Modification Recommended Service Note

N8929A - Autoranging System DC Power Supply, 750V, 40A, 10000W, 208 VAC

Serial Numbers: DE14290000 - DE15369999 without manufacturing ID Version "B"

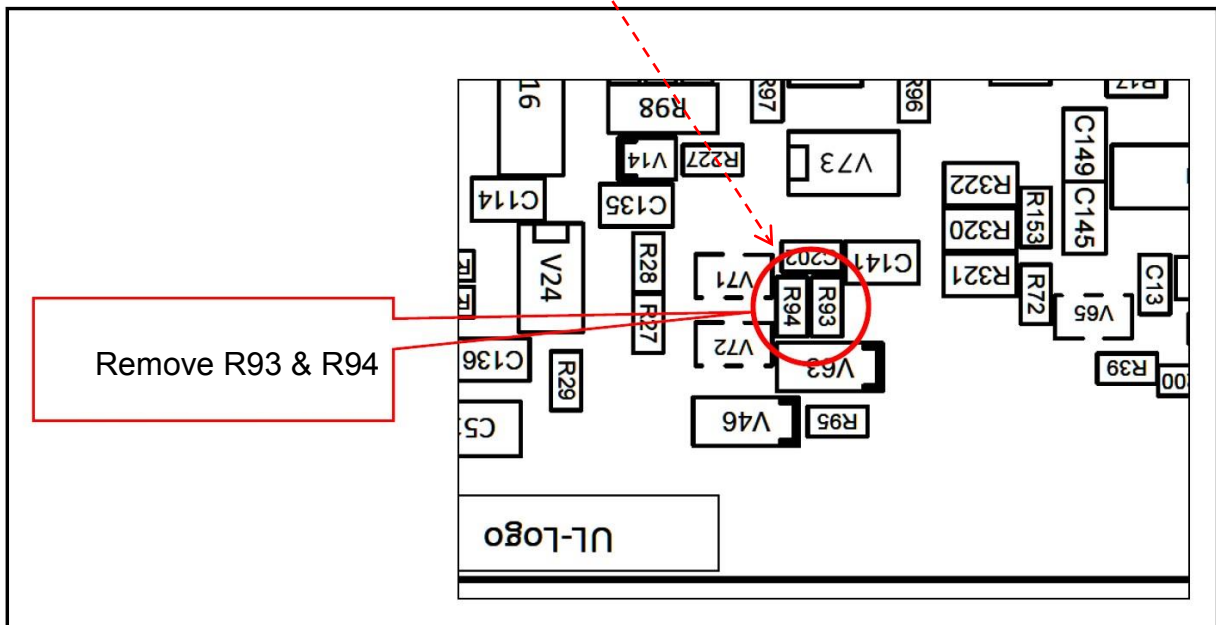
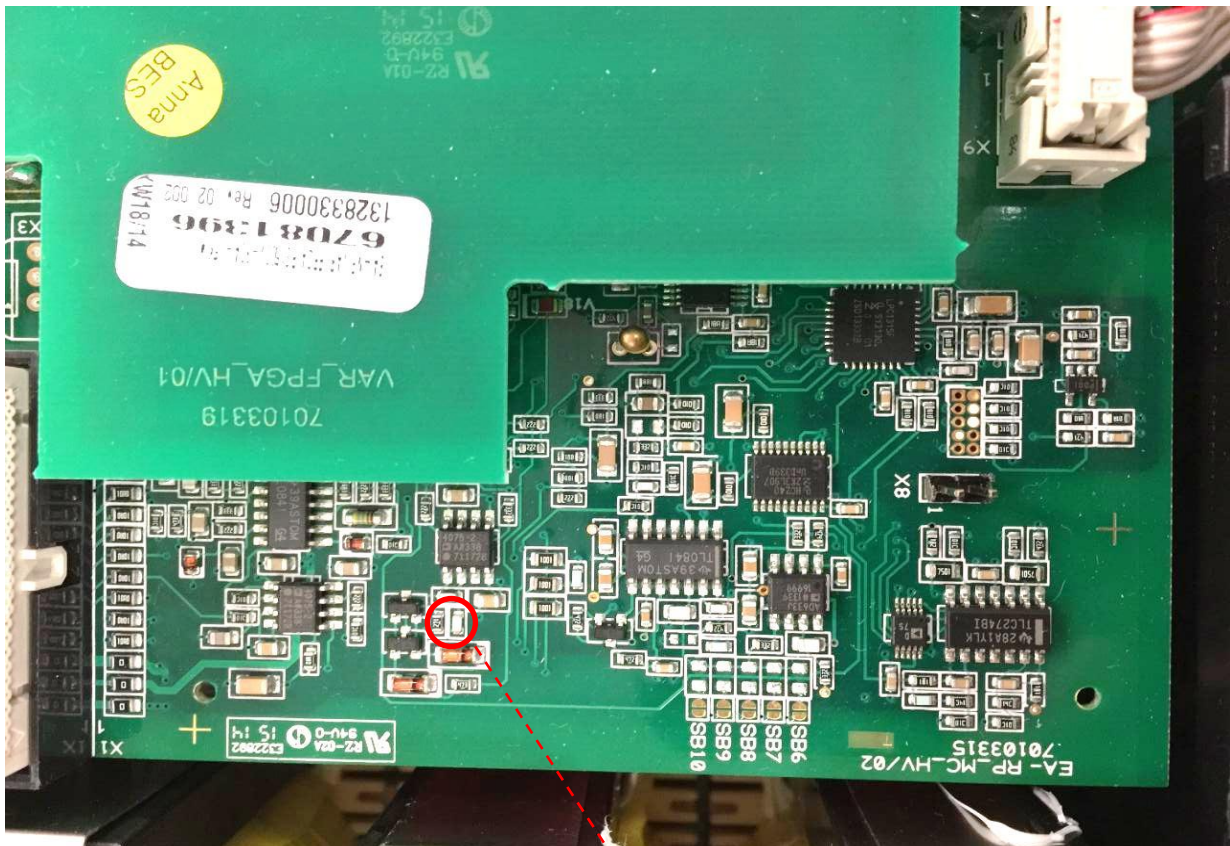
- 1) Remove acMains cable from power source.
- 2) Wait 5 minutes
- 3) Remove top cover from instrument.
- 4) In the 5kW units (viewed from the front of the unit), a small SMT assembly located at the right-rear of instrument will be readily visible (see below):

In the 10kW & 15kW units; although found in the same location, a black plastic cover will have to be removed to gain visibility and access to the SMT assembly. Plastic cover snaps-on and can be removed with a small screwdriver.

5) SMT resistors R93/94 are located in red circle shown below:

Removal of two (2) surface mount resistors, R93 and R94, will correct this problem:

Suffix “B” added

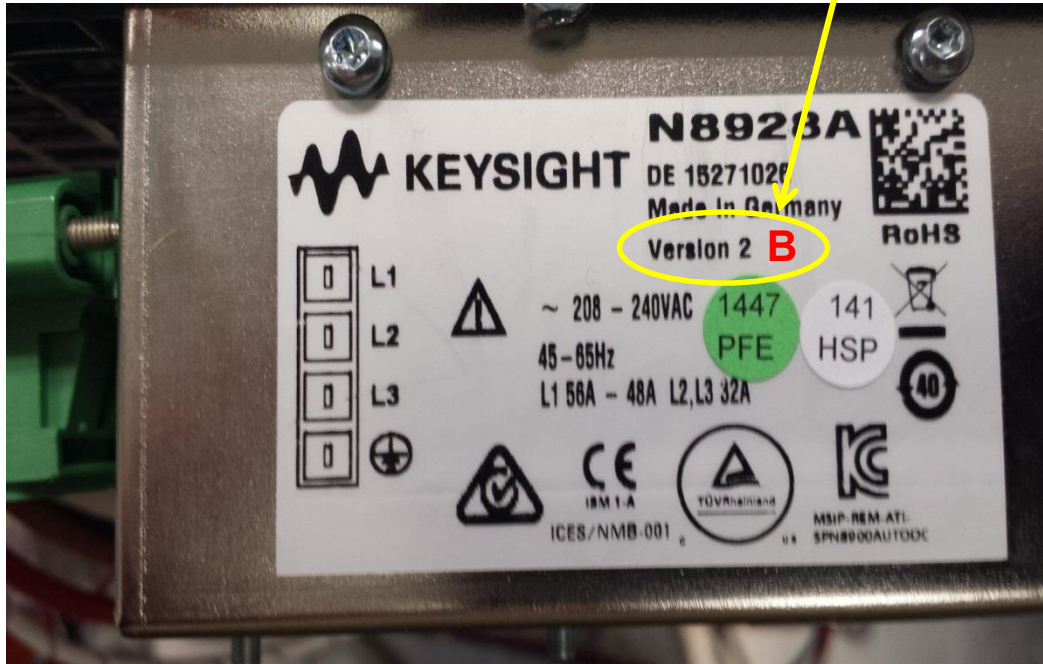
7) On the acMains label, on the rear of the instrument; use an indelible marker, to add the suffix letter “B” after the Version ID. This will assist in the tracking of modified instruments.
